REPLACEMENT TRANSPORT SWITCH / READY LIGHT

p/n 94277

ROCKER SWITCH TERMINAL CONFIGURATION VIEWS

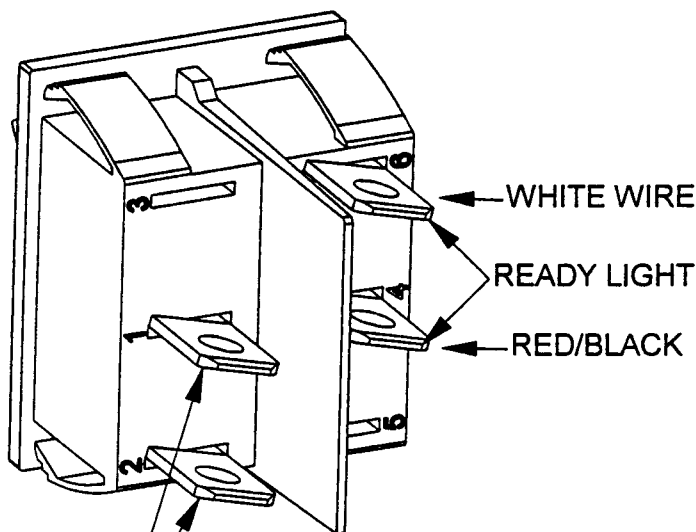
The new switch supplied in this replacement kit may have a slightly different TERMINAL CONFIGURATION than the part being replaced. The quality & reliability of the part has been improved, and as result, ONE of the READY LIGHT terminals has been moved from POSITION #4 to POSITION #5. Refer to the TERMINAL CONFIGURATION VIEWS and determine the part you are replacing. The WHITE wire still connects to TERMINAL #6, the RED W/BLACK stripe will now connects to TERMINAL #5 (Formally TERMINAL #4, or the MIDDLE TERMINAL).

READY LIGHT LEADS CONNECT
AT TERMINALS 6 & 4

115VAC TRANSPORT SWITCH LEADS
TERMINALS 1 & 2
TYPICAL FOR BOTH OLD & NEW SWITCHES

READY LIGHT LEADS CONNECT
AT TERMINALS 6 & 5
